# FASS Programme

Day-Ahead System Services Auction  
(DASSA) Product Review & Locational  
Methodology Recommendation Paper

August 2024

Figure 3: Example supporting the need to reduce FFR FAT from 2 seconds to 1 second (based on 2025 studies).

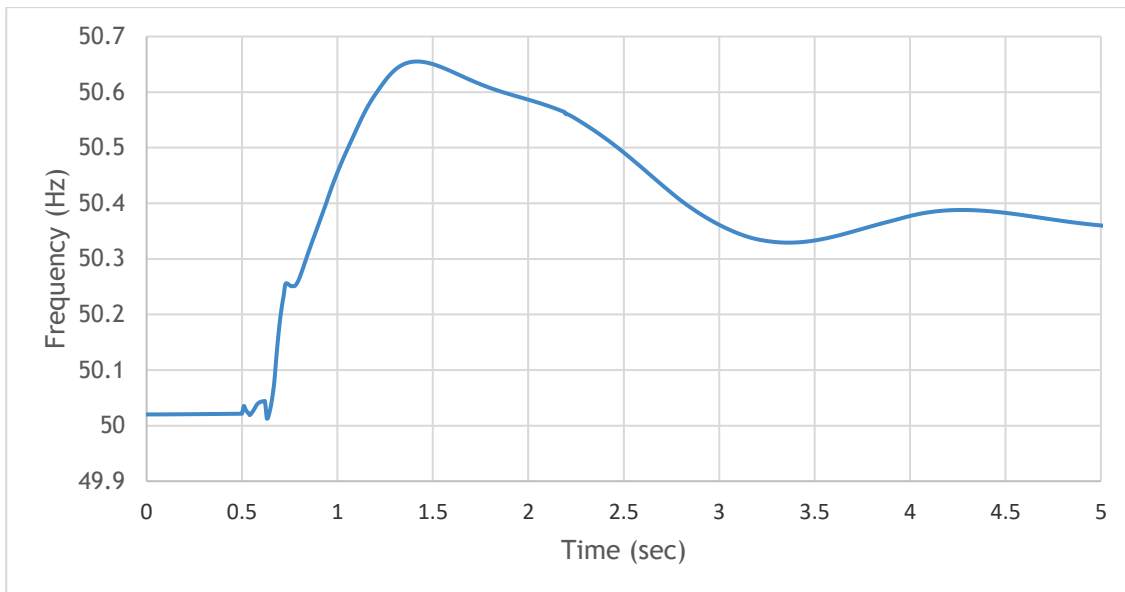
The responses received to Question 3 indicated that while several respondents agree and some disagree with the TSOs' recommendations on increased capabilities in FFR speed of response, several respondents consider it unclear why the FFR FAT is being reduced to 1 second from 2 seconds. For example, one respondent indicates that the consultation paper *'presents only limited evidence supporting volume needs for these faster levels of FFR.'* and suggest that *'it is unclear why the Full Activation Time (FAT) of Fast Frequency Response (FFR) is being reduced to 1 second, from 2 seconds.'* This respondent *'believe[s] that 2 seconds is entirely satisfactory and does not need change. The requirement for a FAT of 2 seconds has been successful in delivering the services required throughout the lifetime of the DS3 framework and no evidence has been provided to showcase that this should have been altered in the past to this extent or that it will create additional benefit by being changed within the future DASSA auction.'*

One respondent refers to the TSOs' Tomorrow's Energy System scenarios which consider possible scenarios for the 2030 - 2050 system. The respondent considers that the paper *'TSO's modelling within Figure 9 does not consider the introduction of alternative energy sources such as hydrogen or biomethane. Thus, ESB GT does not believe that any evidence has been provided to justify the FFR FAT to be reduced to 1 second as a minimum standard and therefore does not support the reduction of the FFR FAT from 2 second to 1 second.'*

Furthermore, some respondents noted that the consultation does not provide the volumes of different FFR speeds, which would make *'it hard to say if there is justification for cutting the maximum FAT for FFR to 1s'*.

While the TSOs agree with the respondents that a FAT of 2 seconds has been successful throughout the lifetime of the DS3 framework, it should be noted that in 2017 the TSOs identified a need for faster FAT for FFR and incentivised (through a scalar) service providers to provide an FFR service with a FAT of up to 150 ms (i.e., critical to frequency stability). In addition, as discussed in chapter 3 of the consultation document, the power system is changing rapidly. Resulting from these developments, decreasing inertia levels, increasing RoCoFs and faster Nadir/Zenith increase the need for faster FFR in future, which is also supported by the studies referred to under Question 1&2.

As an example, Figure 3 below from the 2025 detailed dynamic studies illustrates that Zenith would happen within 1 second following the contingency, and therefore has driven the need for a minimum FFR FAT of 1 second.

Figure 4: Evolution of frequency nadir in 2026 with and without LCIS<sup>15</sup>

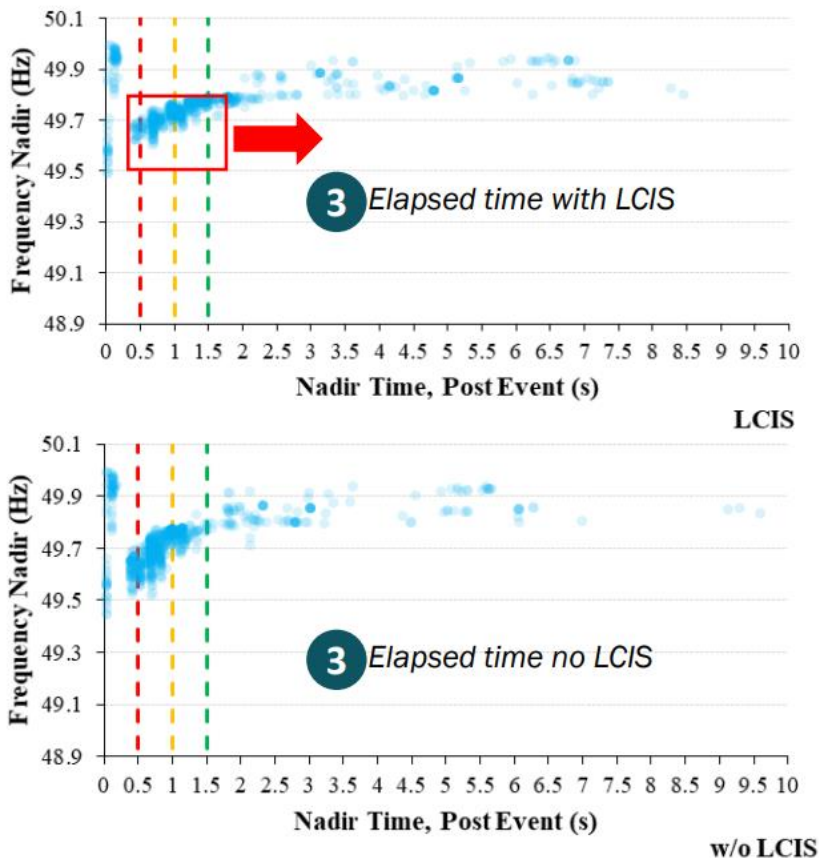
Some respondents suggest alternatives, including that the need for increasing FFR speed can alternatively be mitigated by holding more inertia. While this is true in principle, the LCIS Phase 1 detailed dynamic studies indicated that even with the addition of LCIS the future power system will experience faster Nadir and Zenith. For instance, Figure 4 below shows that while LCIS will help move Nadir occurrences to the right, there will still be a lot of instances when Nadir will happen quicker than 2 seconds. In other words, elapsed time between incident (fault and/or loss) and frequency nadir/zenith is expected to be significantly shorter in the future. For this reason, the TSOs believe that the proposed FAT of 1 second of FFR is not a short-term view but rather a necessity to ensure stable operation of the All-Island power system.
